BID ADDENDUM #4

**Nanuet Union Free School District
103 Church Street
Nanuet, NY 10954**

Nanuet Bond Projects Phase 3

Date: July 7, 2023

ISSUED: BID SET ISSUANCE
DATE: 6/6/2023
SCALE: As indicated
SHEET NAME:
 PARTIAL SECOND FLOOR
 INTERIOR FINISH AND
 FURNITURE PLANS
SHEET NUMBER:

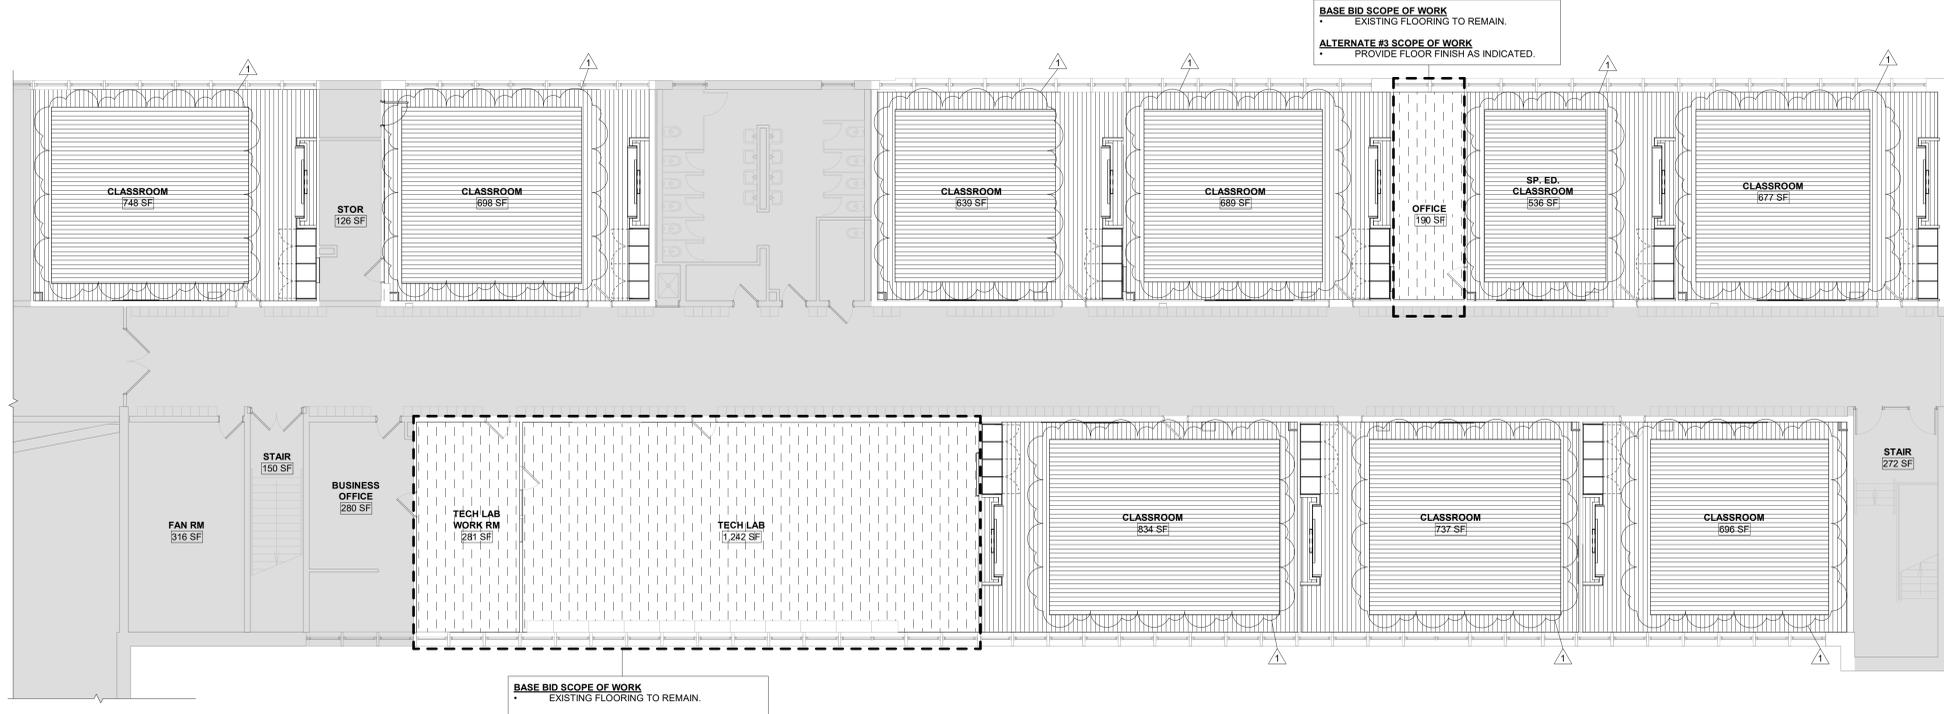
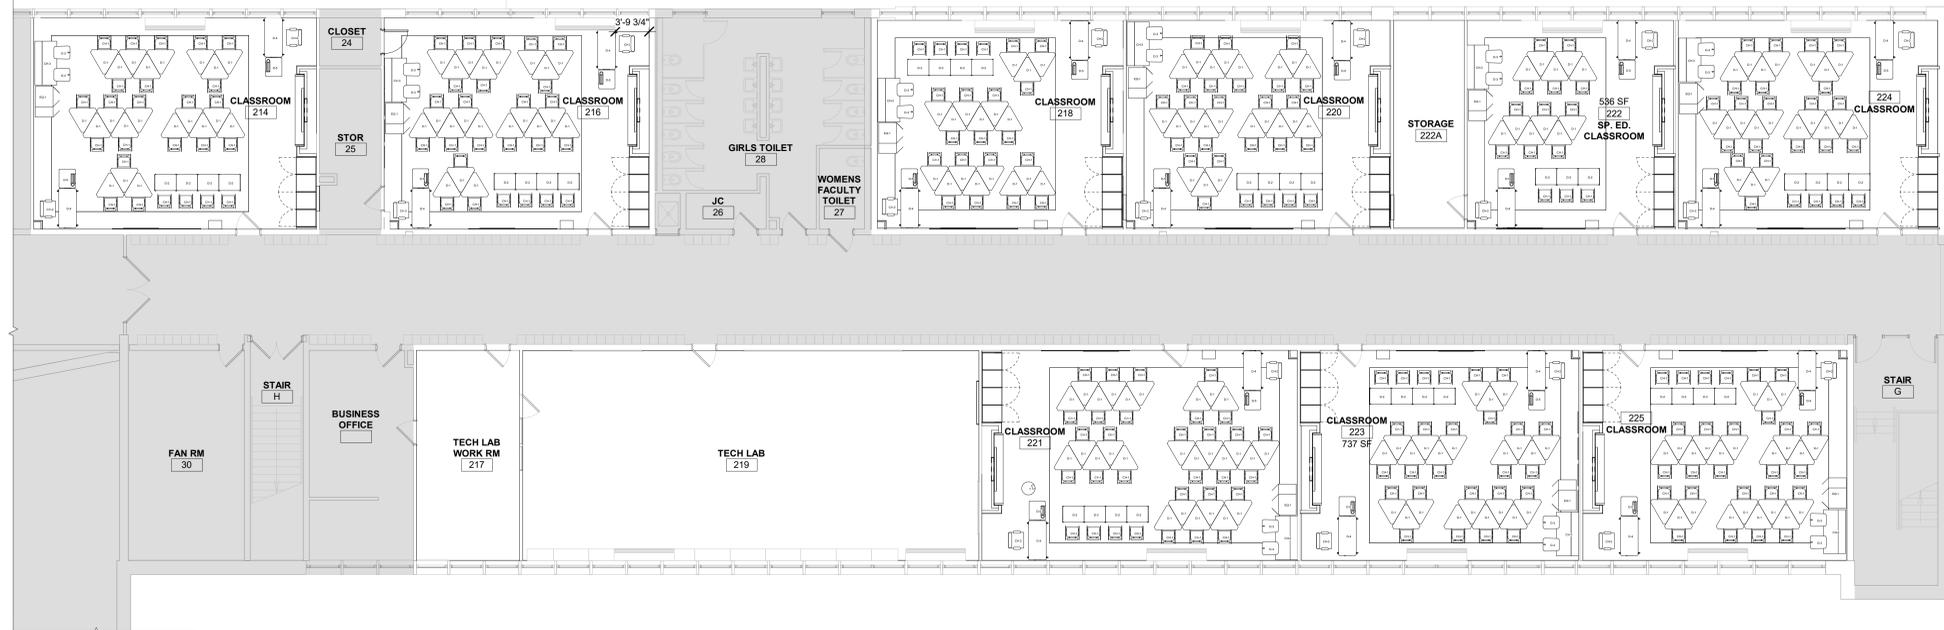
17. The hatch for LVT flooring indicates that the LVT only gets installed on the the perimeter of each classroom. Please confirm what material gets applied in the middle of the classrooms where there is no hatch indicated. See attached drawing for reference

1. **HS-A832**
 - a. Drawing updated to show classroom LVT-1 horizontal installation.
2. **BM-M601**
 - a. Added unit ventilator heating coil piping connection Detail K4

Response: Drawing HS-A832 has been updated to show the LVT hatch to be installed in the middle of the classrooms.
